## #11175A: Special Coverage Adjustment -Shift Lever May Not Display Correct Gear - (Feb 11, 2013)

Subject: 11175A – Special Coverage Adjustment — Shift Lever May Not Display Correct Gear

Models: 2007-2008 Saturn AURA

The service procedure in this bulletin has been revised to include the installation of a cable kit (clam shell). Please discard all copies of bulletin 11175.

Note: Hybrid vehicle shown. Combustion engine vehicle is similar.

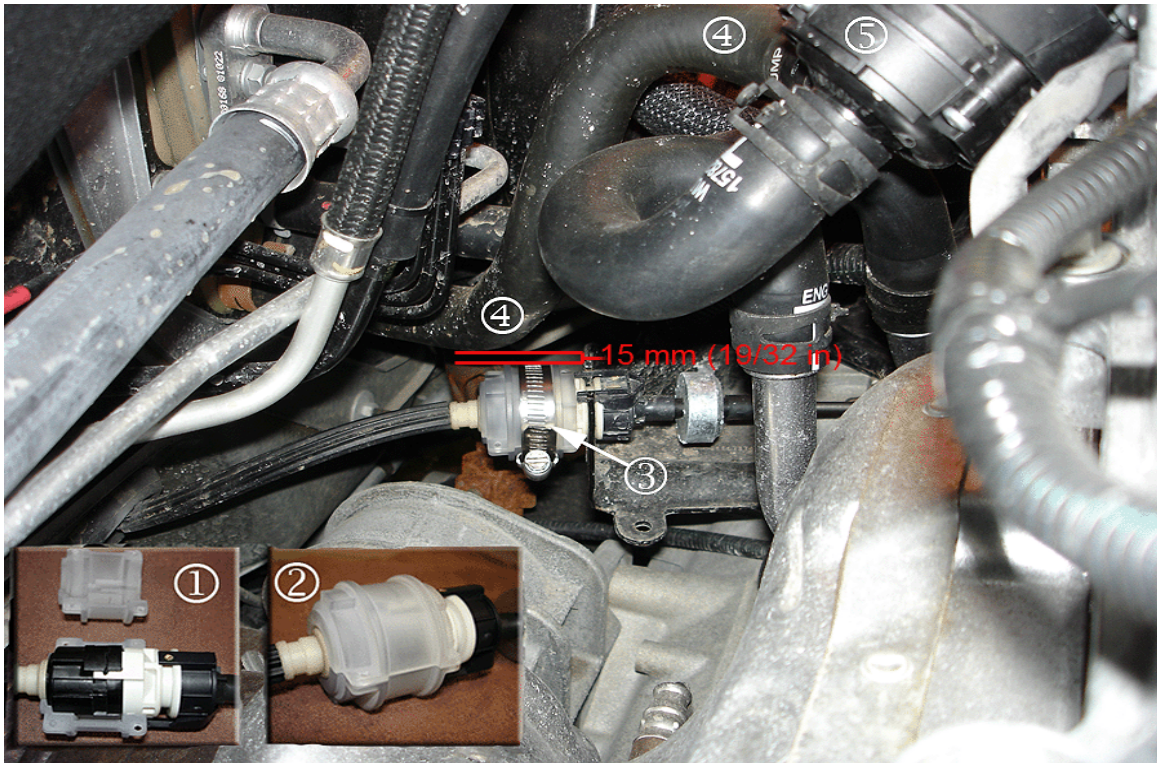
3. Remove and discard the cable bracket (4).
4. Install a new floor shift control cable and new bracket. Refer to *Floor Shift Control Cable Replacement* in SI.

5. Install the clam shell (1) (2) over the shifter cable locking tabs.
6. Install the service clamp over the clam shell (3). Position the clamp fastener head away from the inlet coolant hose (4). *Tighten the clamp to 4 N·m (35 lb-in).*
7. Ensure that there is 15 mm (19/32 in) of clearance between the inlet coolant hose (4) and the clam shell (3). On hybrid equipped vehicles, it may be necessary to reposition the inlet coolant hose (4) to achieve the required 15 mm (19/32 in) of clearance. *To reposition the inlet coolant hose (4) on hybrid equipped vehicles, locate the heater cooler pump (5) and perform Steps 5.1-5.4.*

Caution Do not kink or damage the inlet coolant hose (4) when repositioning the hose to obtain the 15 mm (19/32 in) clearance. To avoid damaging the hose clamp, use J-38185 or equivalent hose clamp pliers to loosen the hose clamp.

- 7.1 Using J-38185 or equivalent hose clamp pliers, loosen the inlet coolant hose (4) connected to the heater cooler pump (5). Note the location of the clamp on the inlet coolant hose (4).

- 7.2 Rotate the inlet coolant hose (4) clockwise until 15 mm (19/32 in) of clearance between the inlet coolant hose (4) and clam shell (3) is achieved.

- 7.3 Ensure that the inlet coolant hose clamp is secure on the inlet coolant hose (4) in the production location.
